Addendum 49 – Regulation No. 50

Revision 3 - Amendment 1

Supplement 17 to the original version of the Regulation – Date of entry into force: 8 October 2015

Uniform provisions concerning the approval of front position lamps, rear position lamps, stop lamps, direction indicators and rear-registration-plate illuminating devices for vehicles of category L

- "1. Front position lamps

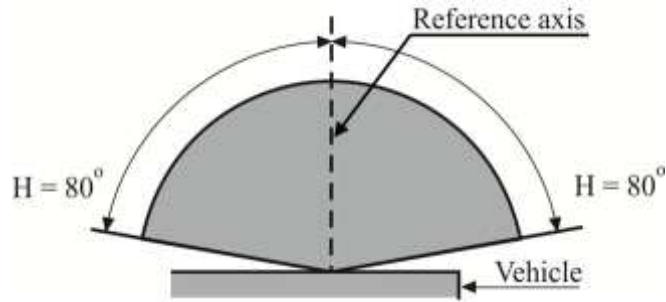
Paragraphs 1. to 4., amend to read:

$$V = +15^\circ / -10^\circ$$

However, in the case where a device is intended to be installed with its H plane at a mounting height less than 750 mm above the ground, the angle of 10° below the horizontal may be reduced to 5° .

Front position lamps (for a pair of lamps)

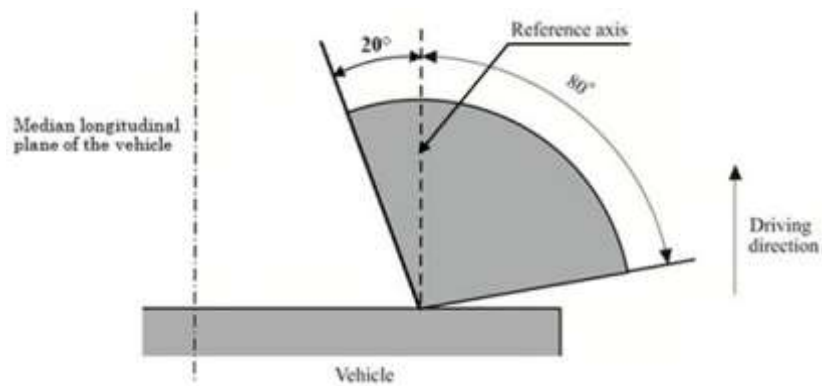
$$V = +15^\circ / -10^\circ$$

However, in the case where a device is intended to be installed with its H plane at a mounting height less than 750 mm above the ground, the angle of 10° below the horizontal may be reduced to 5° .

2. Rear position lamps

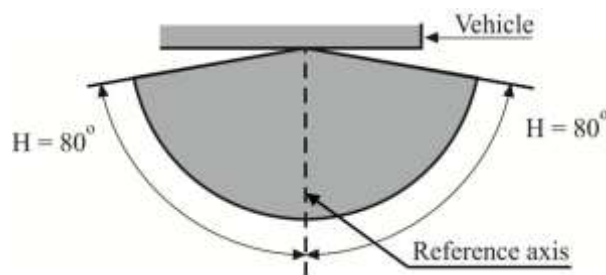
$$V = +15^\circ / -10^\circ$$

However, in the case where a device is intended to be installed with its H plane at a mounting height less than 750 mm above the ground, the angle of 10° below the horizontal may be reduced to 5° .

Rear position lamps (for a pair of lamps)

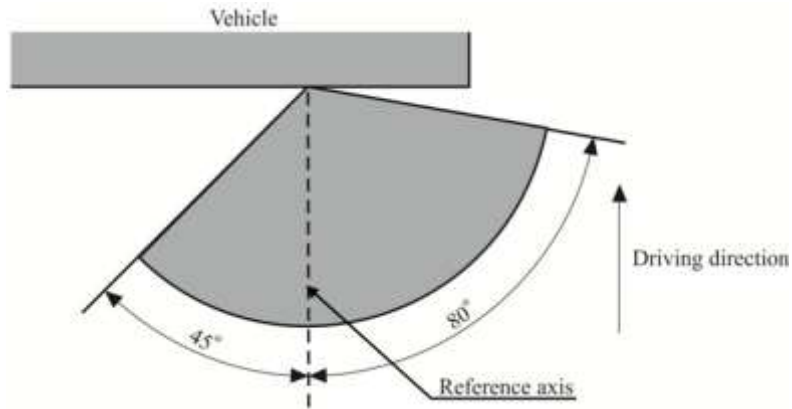
$$V = +15^\circ / -10^\circ$$

However, in the case where a device is intended to be installed with its H plane at a mounting height less than 750 mm above the ground, the angle of 10° below the horizontal may be reduced to 5° .

However, in the case where a device is intended to be installed with its H plane at a mounting height less than 750 mm above the ground, the inward angle of 45° may be reduced to 20° under the H plane.

3. Direction indicators of categories 11, 11a, 11b, 11c and 12

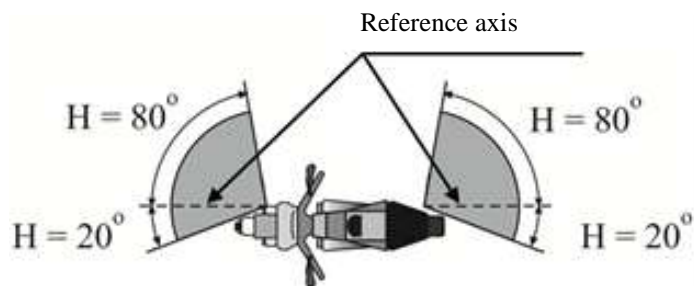
$$V = \pm 15^\circ$$

Minimum horizontal angles of light distribution in space:

Categories 11, 11a, 11b and 11c: direction indicators for the front of the vehicle;

Category 11: for use at a distance not less than 75 mm from the passing-beam headlamp;

Category 11a: for use at a distance not less than 40 mm from the passing-beam headlamp;

Category 11b: for use at a distance not less than 20 mm from the passing-beam headlamp;

Category 11c: for use at a distance less than 20 mm from the passing-beam headlamp.

However, in the case where a device is intended to be installed with its H plane at a mounting height less than 750 mm above the ground, the angle of 15° below the horizontal may be reduced to 5°.

4. Stop lamps

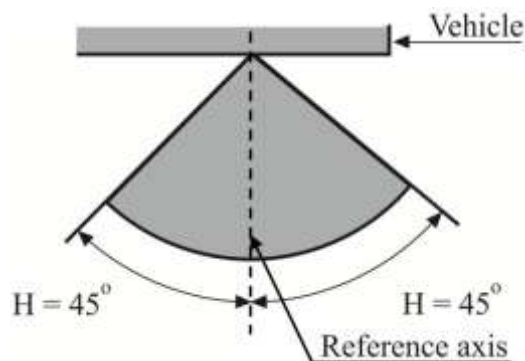
$$V = +15^\circ/-10^\circ$$

However, in the case where a device is intended to be installed with its H plane at a mounting height less than 750 mm above the ground, the angle of 10° below the horizontal may be reduced to 5° .

However, in the case of a pair of lamps, the inboard geometric visibility requirement is deemed to be satisfied if the lamps conform to the photometric values prescribed in the field of light distribution for the approval of the device."

Examples of arrangement of the approval marks

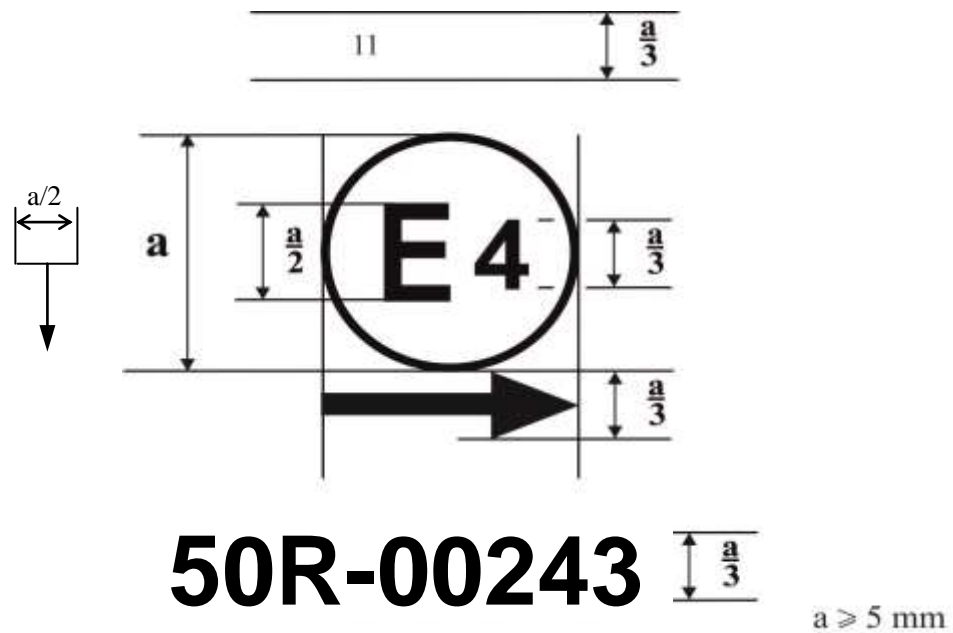
Annex 3, amend to read:

A device bearing the approval mark shown above is a direction indicator of the category 11 approved in the Netherlands (E 4) under the number 00243. The first two digits of the approval number indicate that the approval was granted in accordance with the requirements of Regulation No. 50 in its original form.

For a direction indicator, the arrow indicates that the luminous distribution is a symmetrical in a horizontal plane and that the photometric values required are satisfied up to an angle of 80° to the right, the device seen in the opposite sense of the light emitted.

The vertical arrow starting from a horizontal segment and directed downwards indicates a permissible mounting height of equal to or less than 750 mm from the ground for this device.
